South Carolina Electric and Gas Company
Virgil C. Summer Nuclear Station (VCSNS) Units 2 and 3

NND-16-0056

Supplement to Proposed Changes to Licensing Basis Documents
(LAR 14-02 S2)

Part 1A Associated Licensing Basis Changes related to auxiliary building Wall 11 design Changes

**UFSAR Appendix 3H, Figure 3H.5-5, Sheet 1 of 3 [*Concrete Reinforcement in Wall 11*]* -
Detailed view of the revised information for the upper portion of reinforcement.**

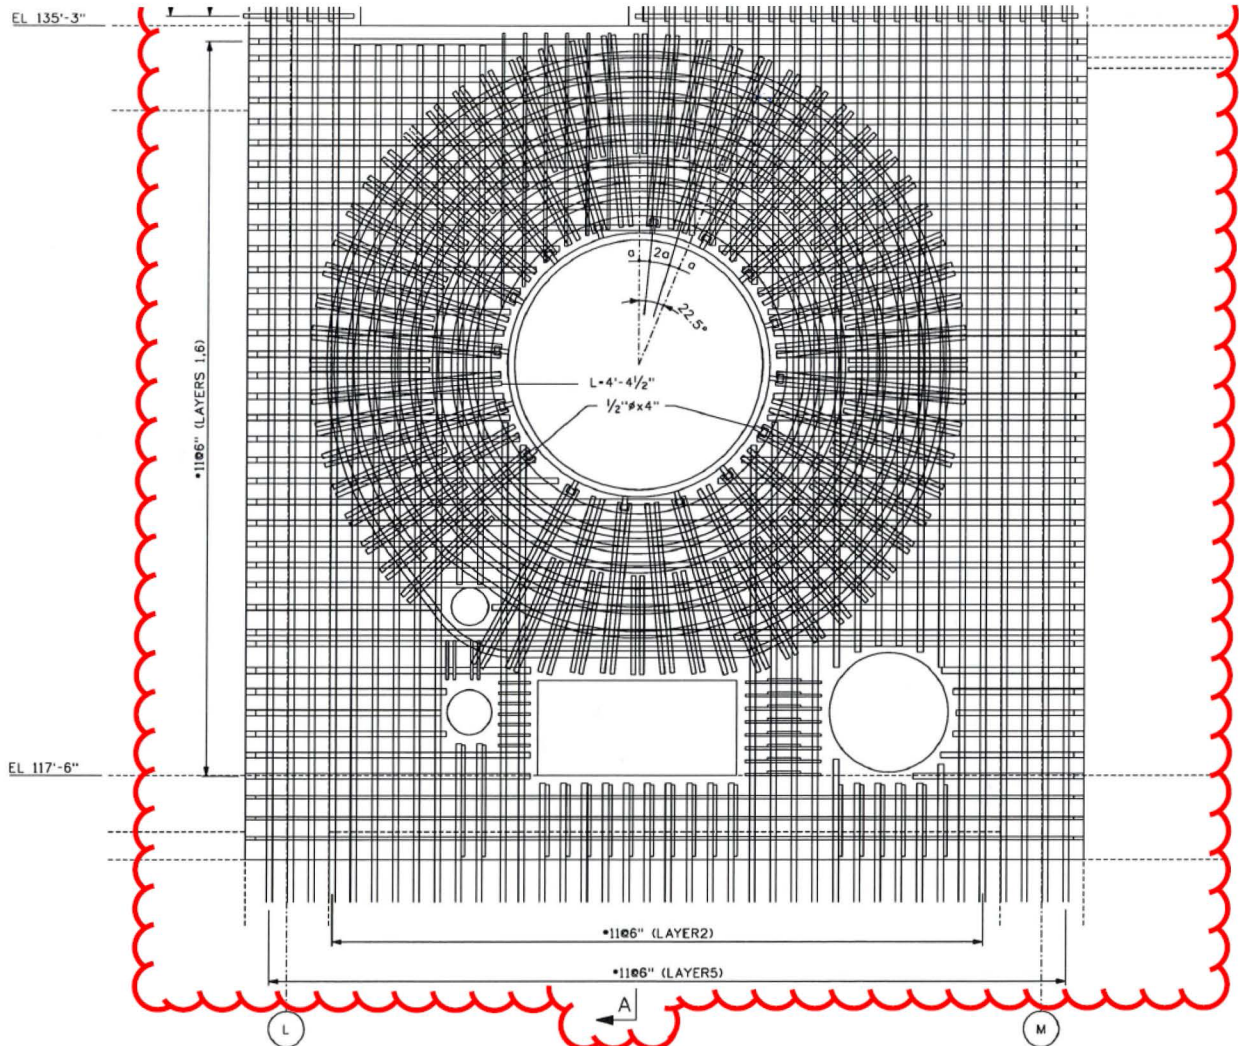
UFSAR Appendix 3H, Figure 3H.5-5, Sheet 1 of 3 [Concrete Reinforcement in Wall 11]* - Detailed view of the revised information for the lower portion of reinforcement.

**UFSAR Appendix 3H, Figure 3H.5-5, Sheet 1 of 3 [*Concrete Reinforcement in Wall 11*]* -
Revise the figure to add notes as shown below.**

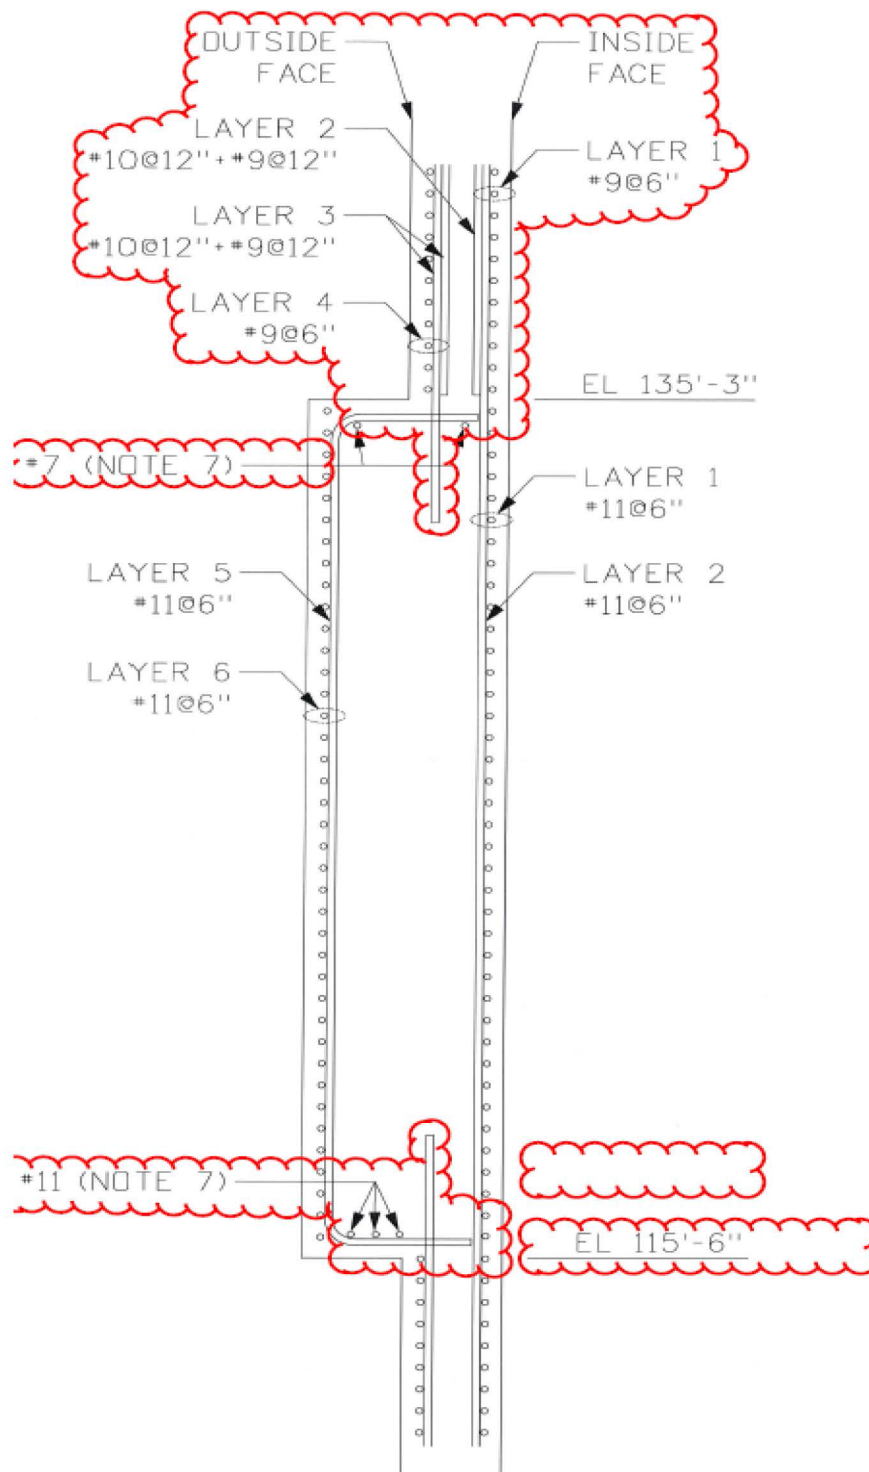
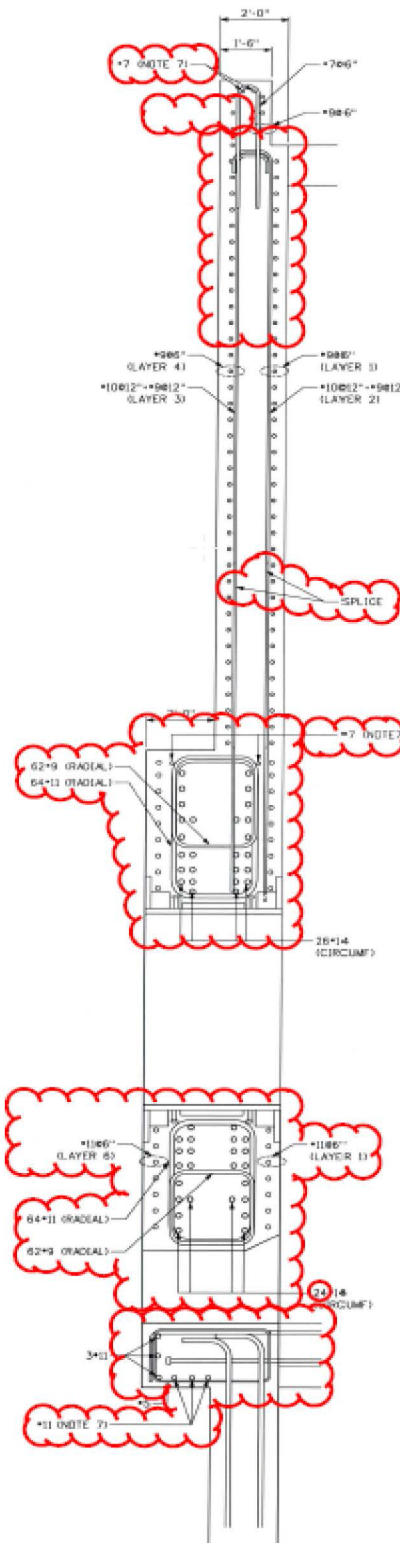
2. LAYER 1, 2, 5 AND 6 REINFORCEMENT TERMINATING WITHIN THE EXTENT OF THE RADIAL AND CIRCUMFERENTIAL REINFORCEMENT AROUND THE PENETRATION IS DEVELOPED USING STANDARD HOOKS OR HEADED REINFORCEMENT (NOT SHOWN). LAYER 3 AND 4 REINFORCEMENT TERMINATING WITHIN THE 4'-0" THICK SECTION IS DEVELOPED WITH EITHER A FULL STRAIGHT DEVELOPMENT ACCORDING TO CHAPTER 12 AND 21 OF ACI 349, OR A FULL STRAIGHT BAR DEVELOPMENT ACCORDING TO CHAPTER 12 OF ACI 349 WITH ADDITIONAL HEADED ANCHORAGE.

6. THE CRITICAL SECTION BOUNDARIES ARE DEFINED IN SUBSECTION 3H.5.1.4.
7. FOR CLARITY, NOT ALL REINFORCING BARS PROVIDED FOR THE PURPOSE OF CRACK CONTROL ARE DEPICTED IN THIS FIGURE. THE NUMBER, SIZE, AND PLACEMENT OF REINFORCING BARS FOR CRACK CONTROL MAY DEVIATE FROM THAT DEPICTED IN THIS FIGURE AS NEEDED TO FACILITATE CONSTRUCTION. PLACEMENT OF REINFORCING BARS FOR CRACK CONTROL SHALL BE IN ACCORDANCE WITH ACI 349-01.

8. FOR CLARITY, OUT-OF-PLANE SHEAR REINFORCEMENT IS NOT DEPICTED IN THIS FIGURE. OUT-OF-PLANE SHEAR REINFORCEMENT SHALL BE IN ACCORDANCE WITH ACI 349-01.

**UFSAR Appendix 3H, Figure 3H.5-5, Sheet 3 of 3 [Wall 11 at Main Steamline Anchor
Section A-A]* - Detailed view of the revised information for the middle portion of the figure.**

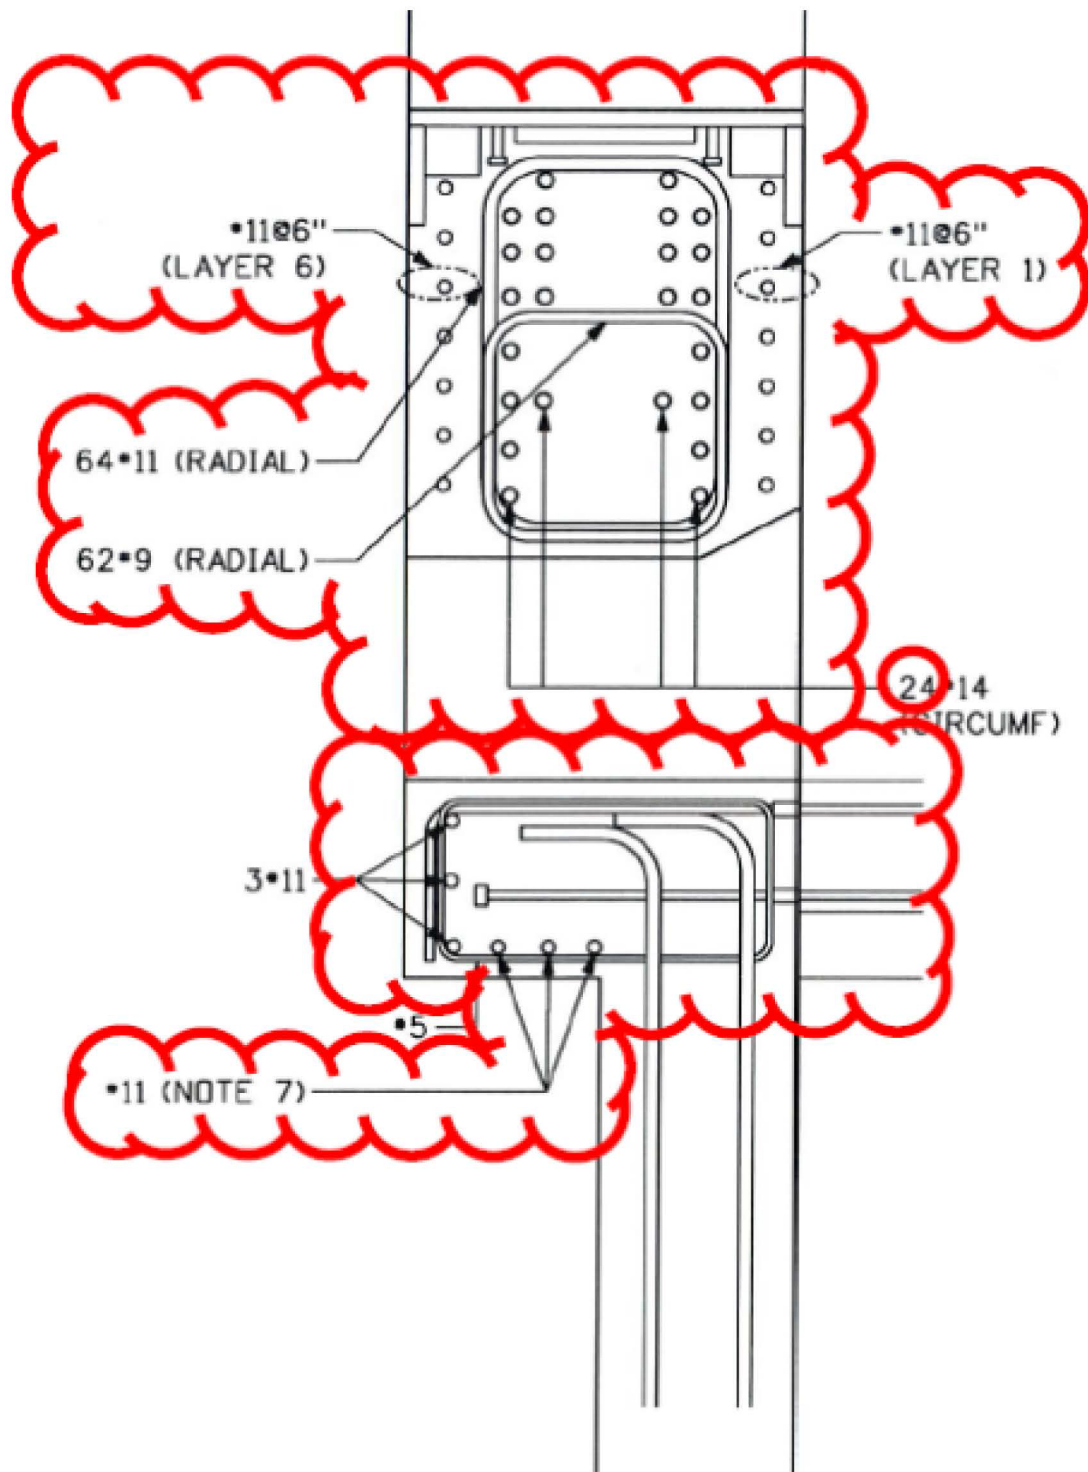
**UFSAR Appendix 3H, Figure 3H.5-5, Sheet 3 of 3 [Wall 11 at Main Steamline Anchor
Section A-A]* - Detailed view of the revised information for the lower portion of the figure.**
